Ref: 9090

Re: Response to 2nd Traffic Peer Review
The Cottages at Old Oaken Bucket - 279-281 Old Oaken Bucket Road
Scituate, Massachusetts

Vanasse & Associates, Inc. (VAI) is providing responses to the comments that were raised in the December 29, 2022 2nd *Traffic Peer Review* letter prepared by Ron Müller & Associates (RMA) in reference to their review of the October 24, 2022 *Response to Traffic Peer Review* (the “October 2022 Response Letter”) prepared by VAI in support of The Cottages at Old Oaken Bucket to be located at 279-281 Old Oaken Bucket Road in Scituate, Massachusetts (hereafter referred to as the “Project”). Listed below are the comments that were identified by RMA in the subject letter pertaining to the October 2022 Response Letter followed by our response on behalf of the Applicant.

FIGURE 1
 279-281 OLD OAKEN BUCKET ROAD
 RADAR FEEDBACK SIGN LOCATION PLAN

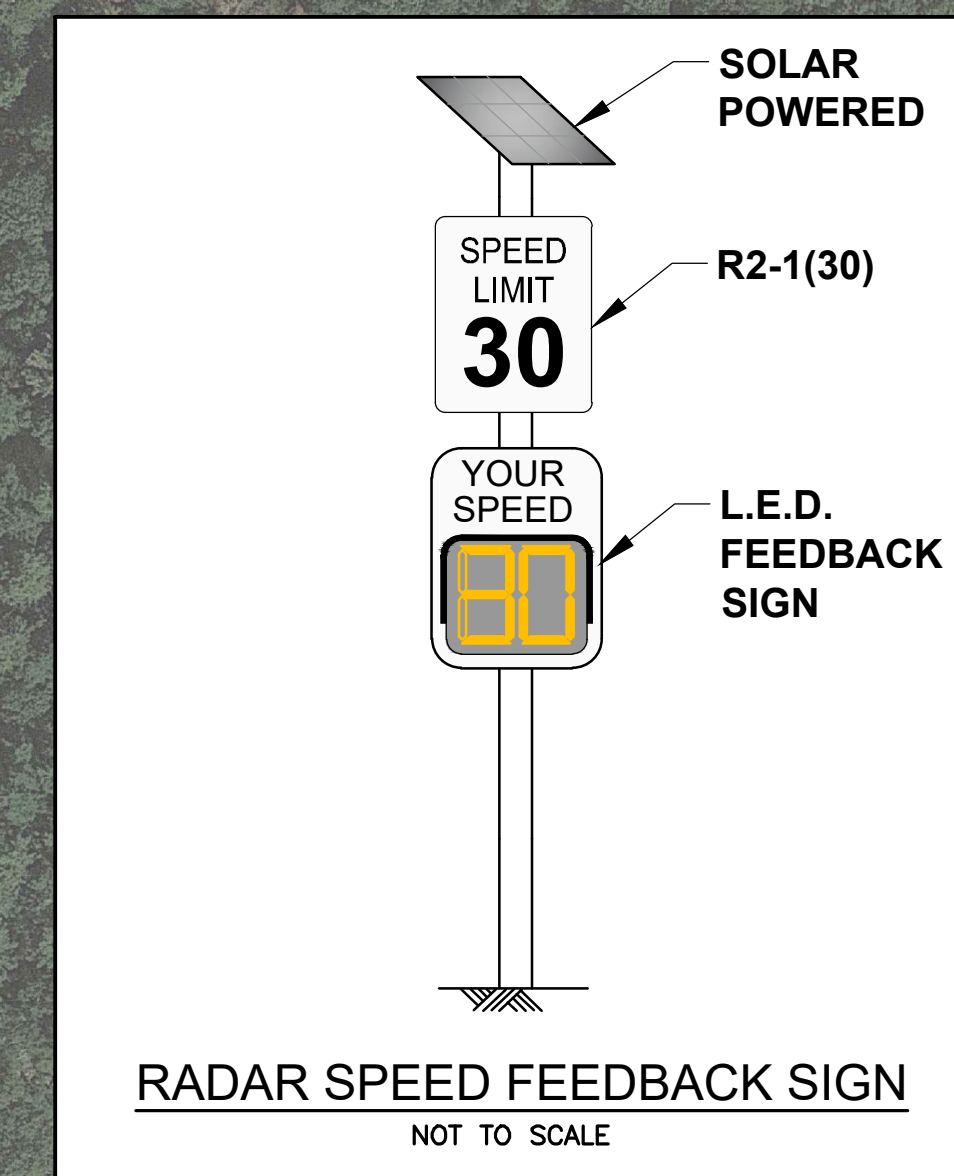
Comment 6: *Accident data were reviewed and summarized within the traffic study. The intersections of Old Oaken Bucket Road at Maple Street / Winter Street and Old Oaken Bucket Road at Route 123 experienced a crash rate higher than both the statewide and district wide averages indicating that safety issues exist. Furthermore, the Scituate rotary has experienced 18 crashes over the five-year period averaging 3.6 crashes per year. A Road Safety Audit (RSA) was conducted in December 2021. The RSA provided suggestions for improvements to enhance safety. RMA suggested that the town include a condition of approval that these RSAs be completed and submitted to the town.*

The town should consider requiring the applicant to investigate and implement these improvements.

In addition, the Applicant has agreed to install radar speed feedback signs on Old Oaken Bucket Road at two (2) locations, east and west of the Project site driveway, in order to moderate travel speeds along this roadway and enhance safety. The suggested locations along Old Oaken Bucket Road for the installation of the radar speed feedback signs are shown on Figure 1.

FIGURE 2
279-281 OLD OAKEN BUCKET ROAD
SIGHT DISTANCE STUDY PLAN

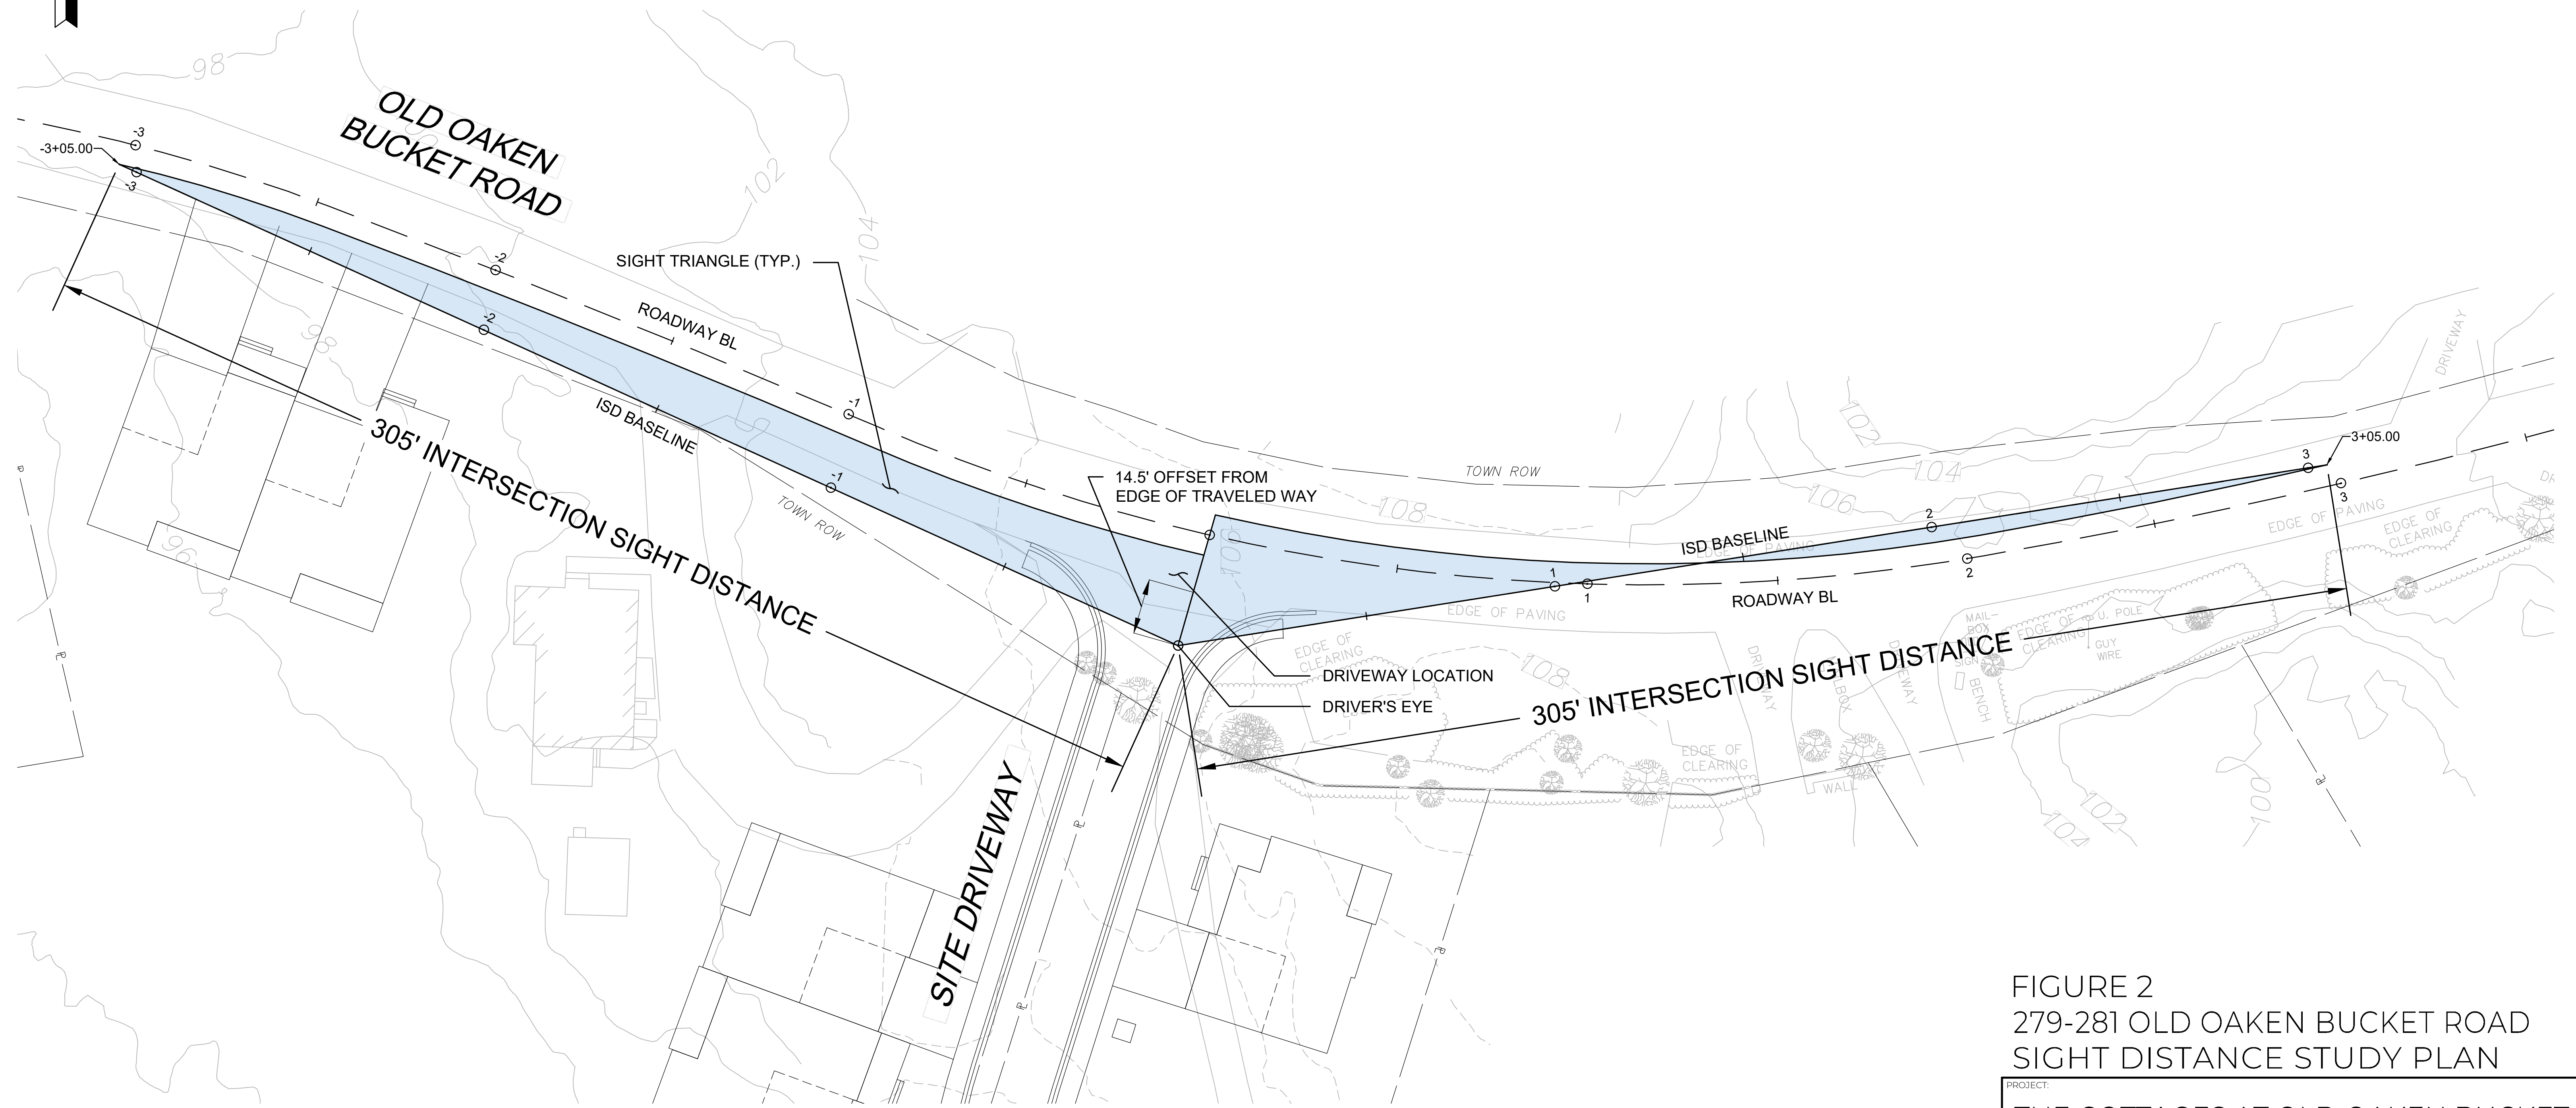
*The sight line plan and profile were not included in the updated plan set. **It is still recommended that a sight line plan and profile be developed to identify the areas of regrading and vegetation removal necessary to ensure that adequate sight distance will exist.***

*The applicant responded that the sight triangle areas will be added to the site plans and a profile of the sight line for motorists exiting the project site driveway will be developed to define the areas of vegetation removal and regrading. These plans were not included with the revised site plans. **It is recommended that the sight triangles at the proposed driveway be shown on the plans.***

Response: Figure 2 depicts the sight lines for the intersection of Old Oaken Bucket Road at the Project site driveway in plan and profile. It should be noted that at the time the field observations that form the basis of the June 2022 *Transportation Impact Assessment*¹ were collected (August 2021), a pile of wood chips/mulch within the public right-of-way to the east of the Project site driveway was limiting lines of sight. At this time, the wood chips/mulch have been removed, affording the required lines of sight looking east from the Project site driveway as shown on Figure 2; however, as noted on Figure 2, signs, landscaping and other features located within sight triangle areas of the Project site driveway shall be designed, installed and maintained so as not to exceed 2.5-feet in height. Snow windrows located within sight triangle areas that exceed 3.5-feet in height or that would otherwise inhibit sight lines shall be promptly removed. The Applicant will accept a condition requiring that the sight triangle area be kept clear of obstructions pursuant to the note on Figure 2.

Response: Figure 2 depicts the sight triangle areas for the Project site driveway. See response to Comment 14.

FIGURE 2
 279-281 OLD OAKEN BUCKET ROAD
 SIGHT DISTANCE STUDY PLAN

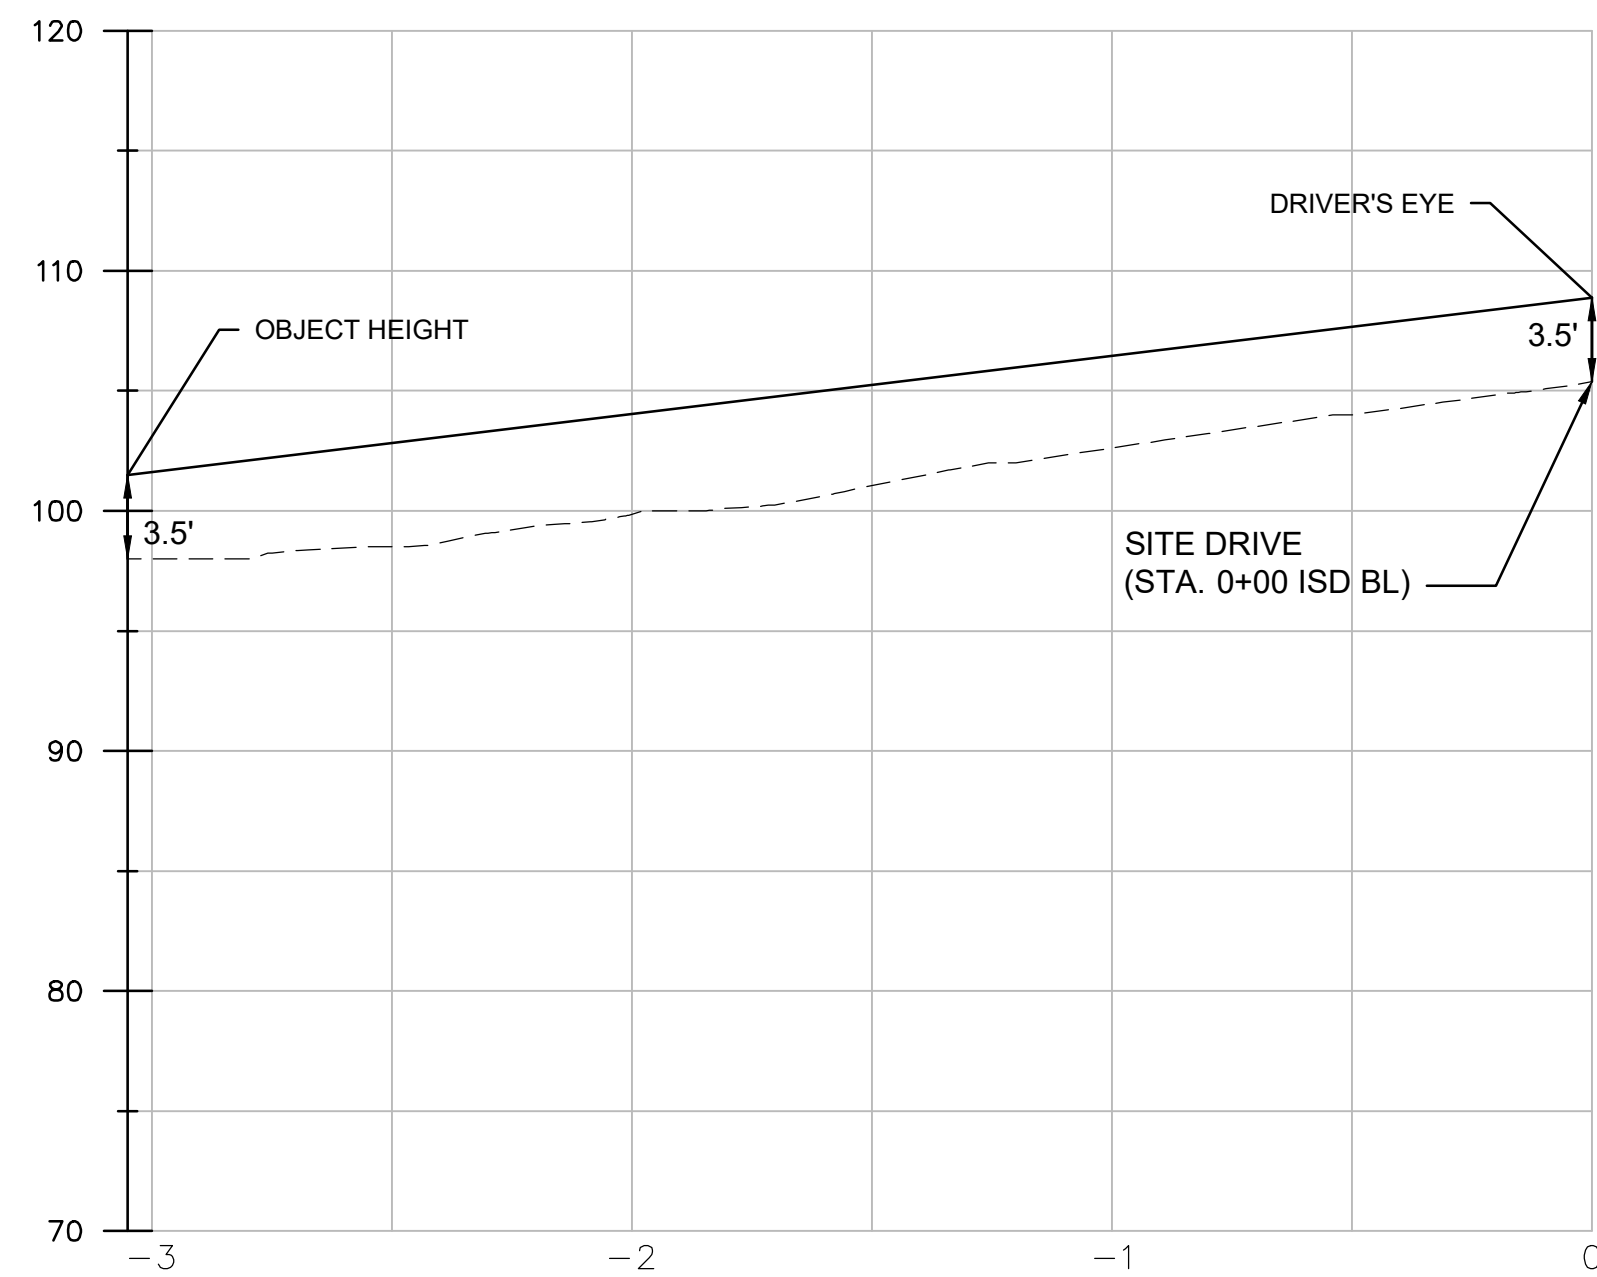
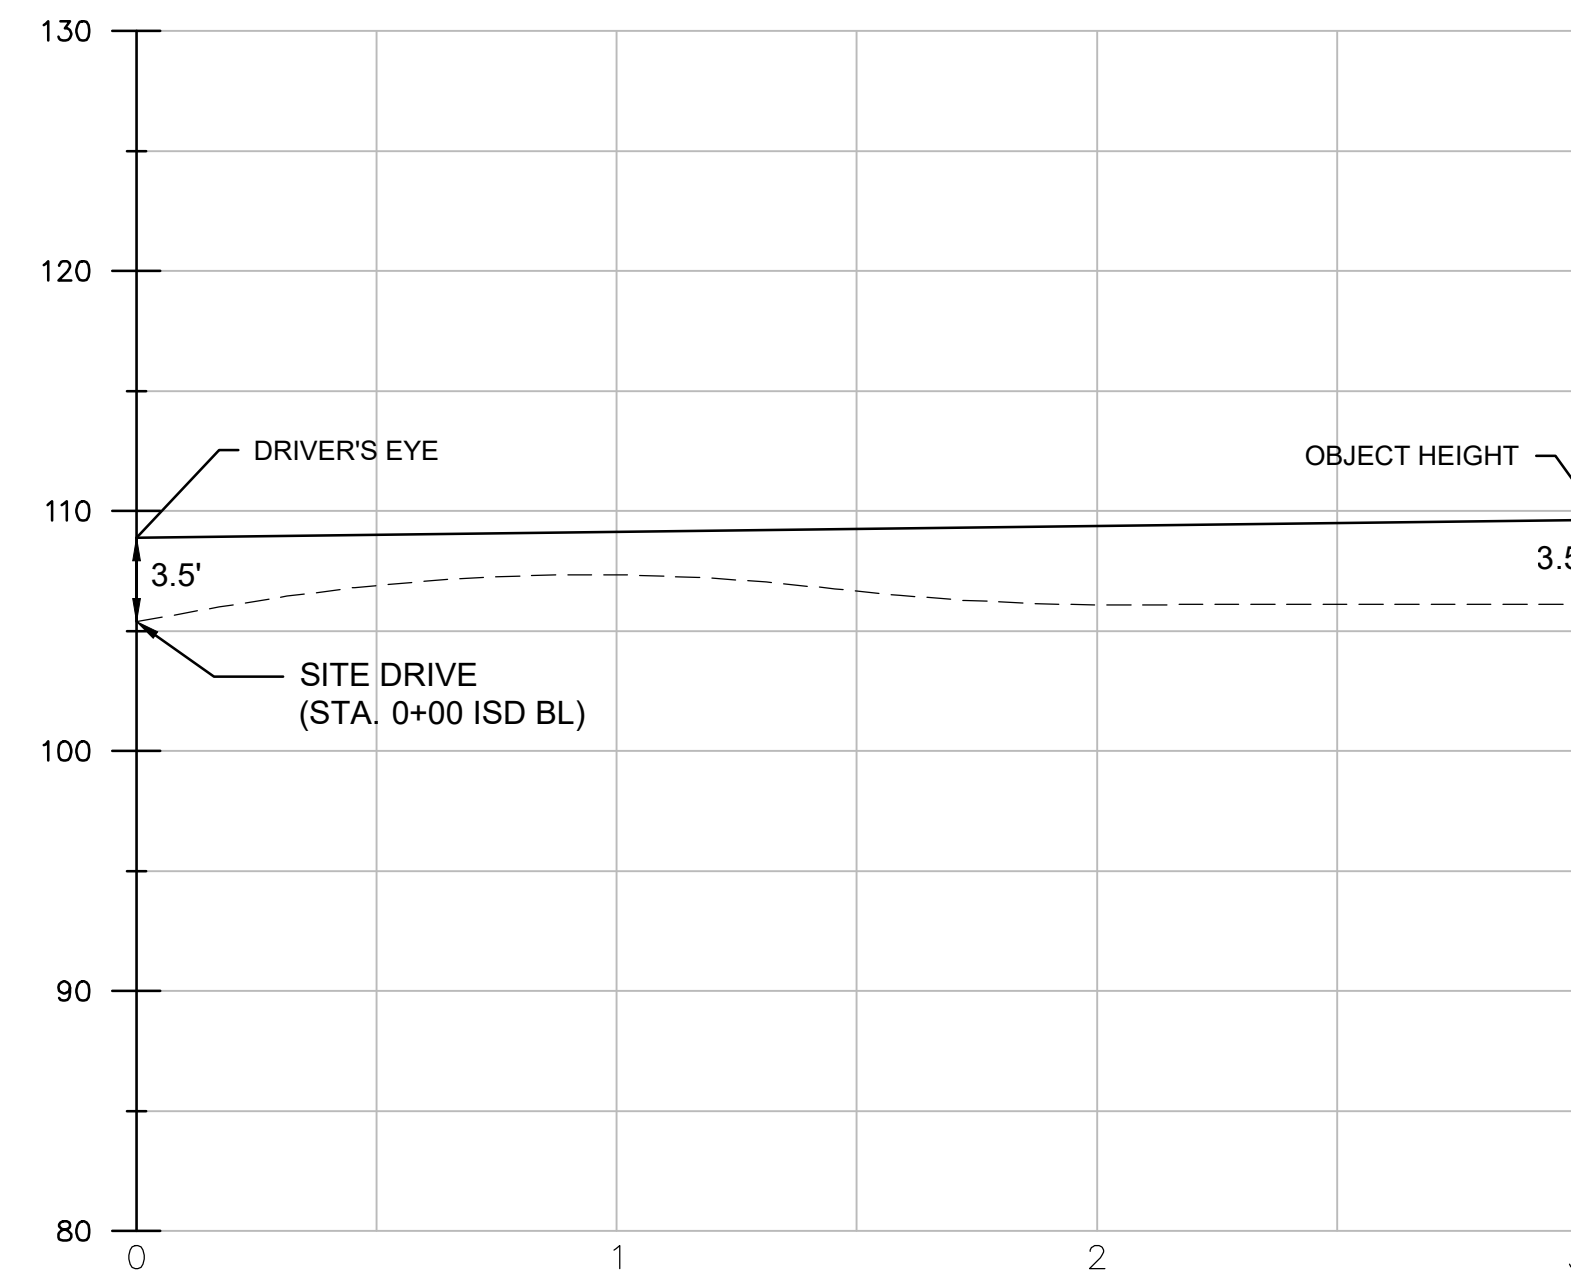
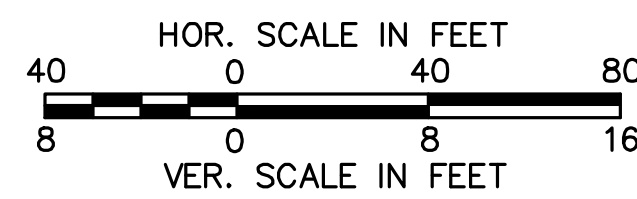
of 40 mph, the minimum required sight distance would be 305 feet in both directions. Table 11 in the study shows that the minimum required distances can be exceeded assuming trimming or removal of trees and vegetation located within the sight triangle areas of the site driveway. The existing embankment to the east of the project site driveway should be regraded in order to provide the required line of sight. A field investigation of the proposed site driveway confirms this information and concurs that vegetation will need to be removed along the south side of Old Oaken Way within the sight triangles and the embankment east of the site driveway will need to be regraded. It was recommended that a sight line plan and profile be developed to specifically identify the areas of regrading and vegetation removal necessary to ensure that adequate sight distance will exist.
